Recall Campaign Bulletin

Campaign No. 2022070006, August 2022

SUBJECT: **Model GLS-Class (167 platform)**
Model Year 2020

Repair Upfront Airbag Sensor Wiring Harness Routing

Figure 2

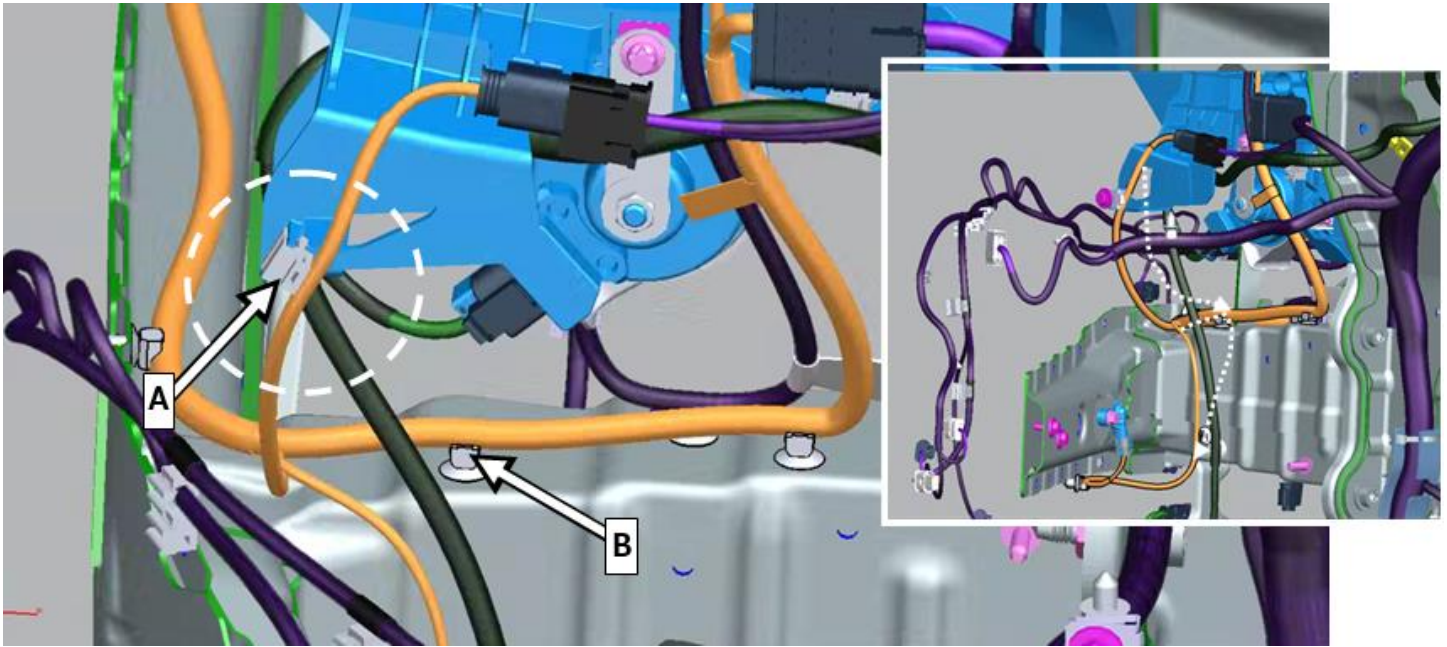
2. Remove bracket (A, figure 2) including cable tie from wiring harness and remove cable tie on bracket (B, figure 2) on upper left longitudinal member.

i Bracket (A, figure 2) will no longer be installed!

Figure 3

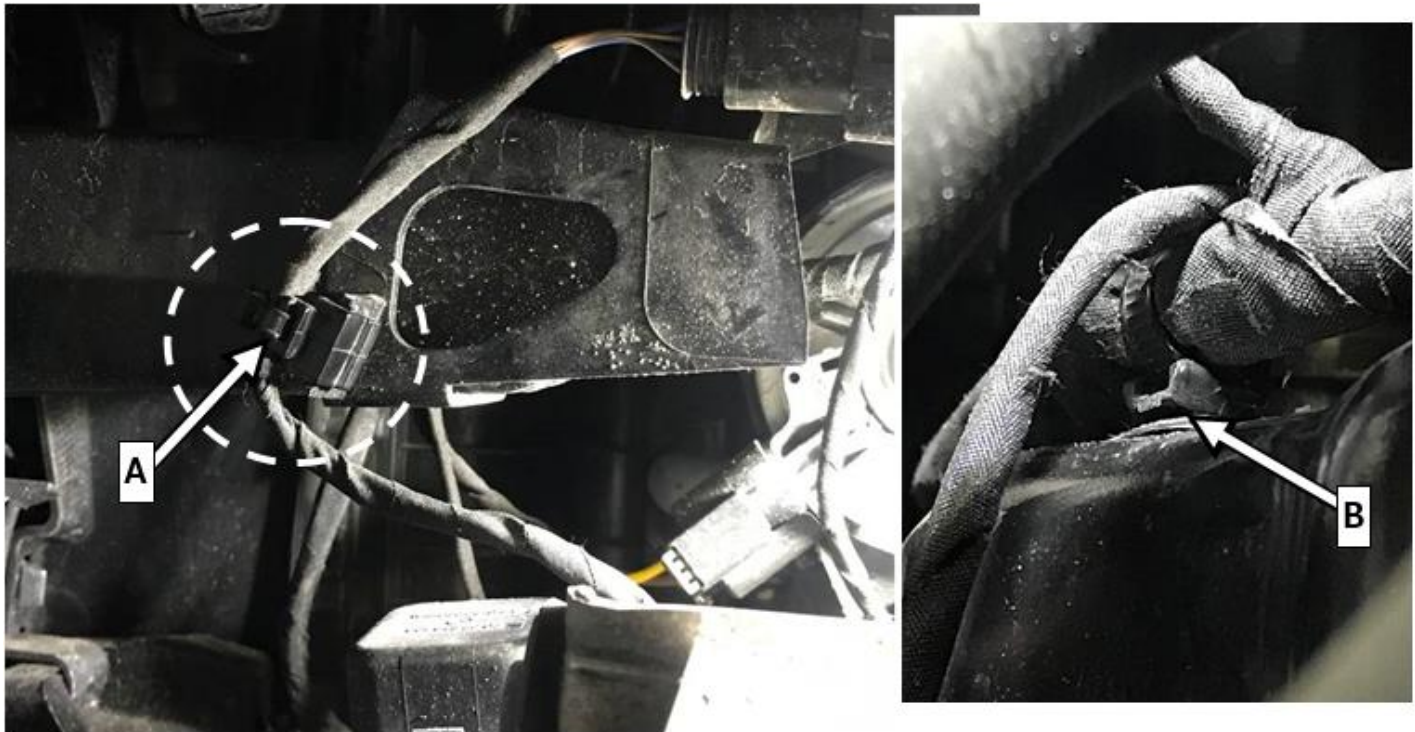
i Figure 3 depicts the original brackets, cable ties, and wire routing for easier identification.

Figure 4

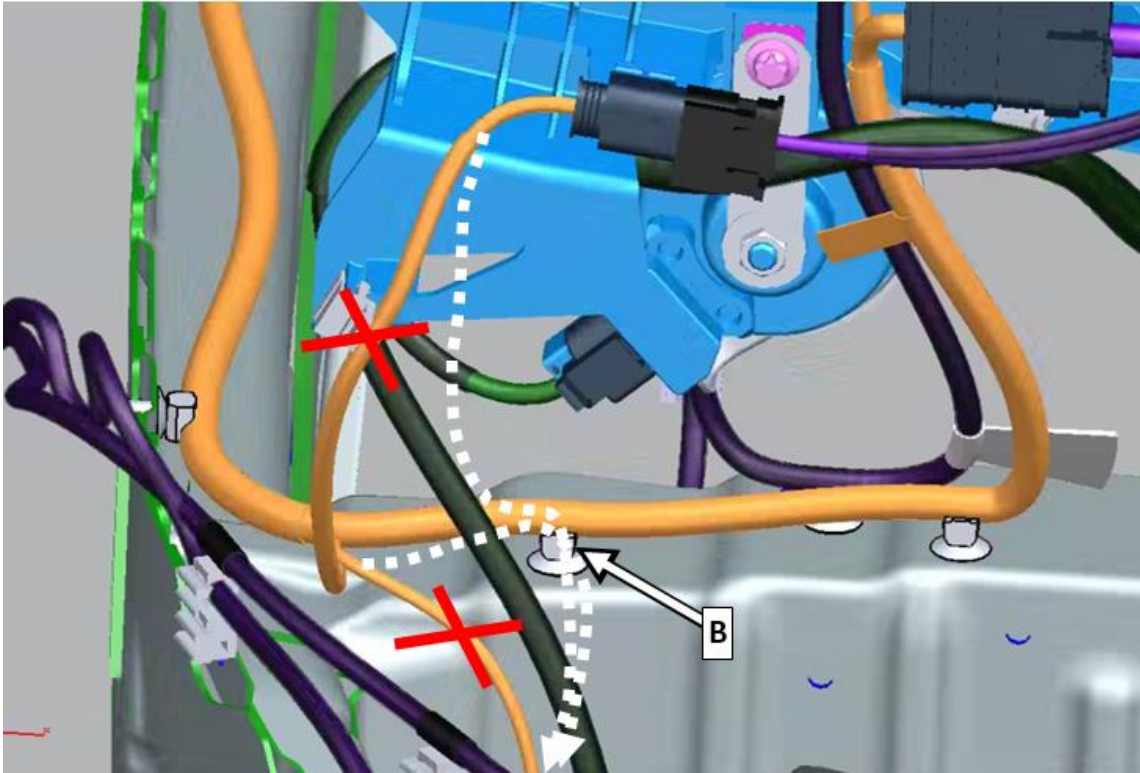
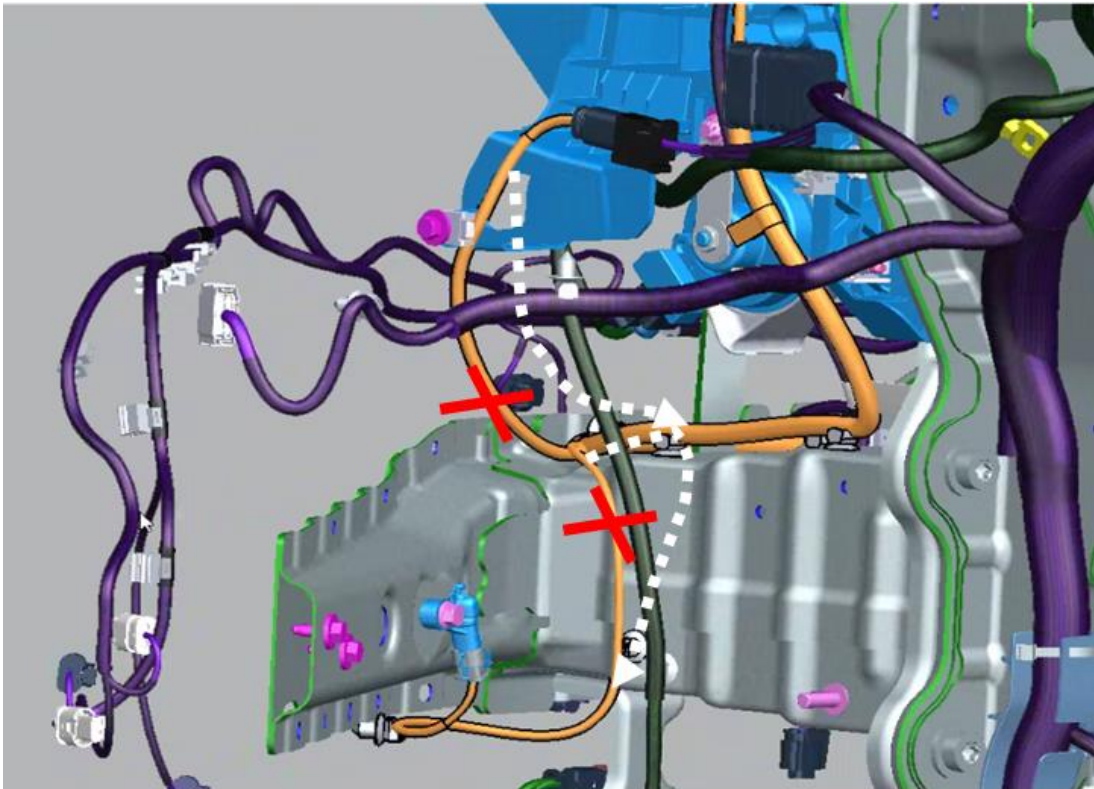
3. Route wiring harness according to **figure 4 and 5**. Fasten with new cable tie to bracket **(B, figure 4)**.

Figure 6

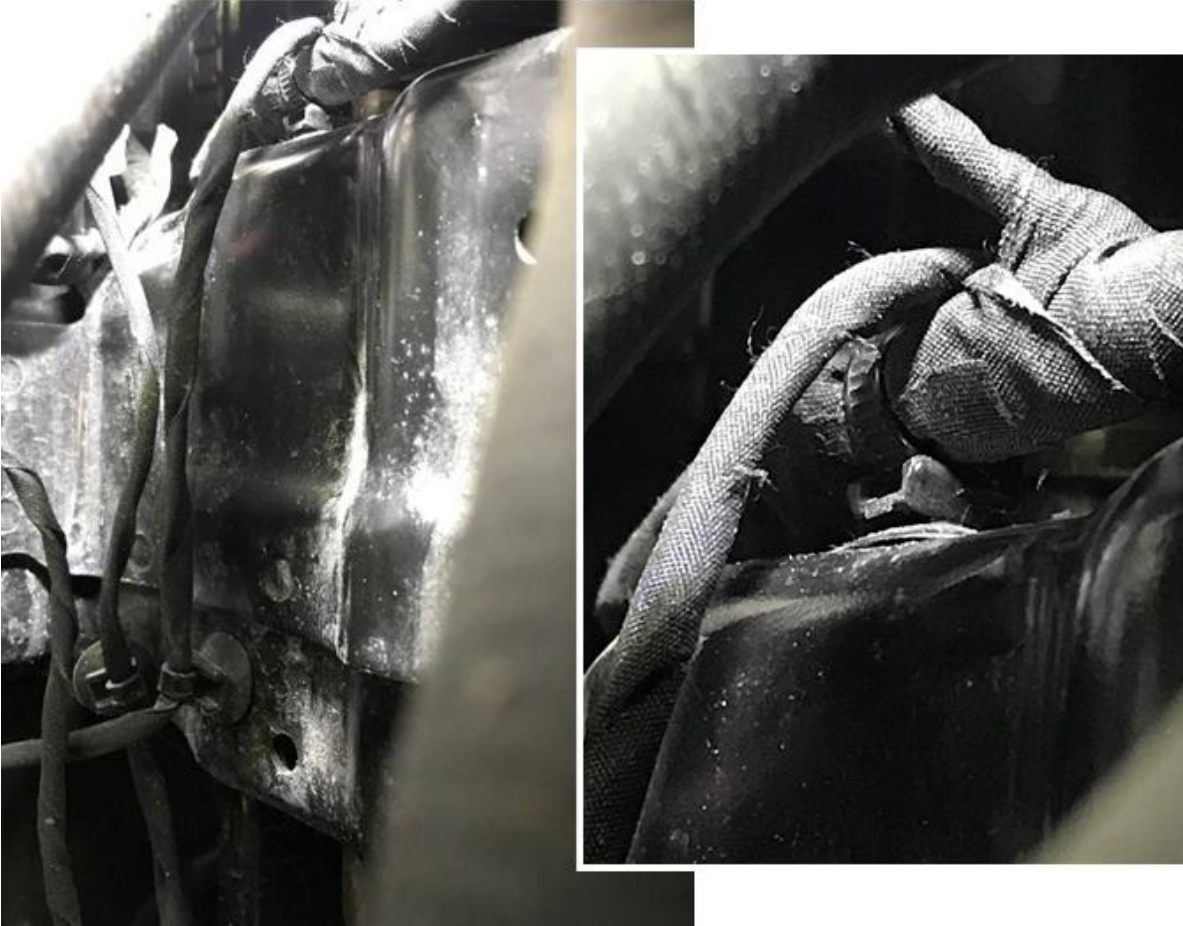
i **Figure 6** depicts the re-worked wiring path.
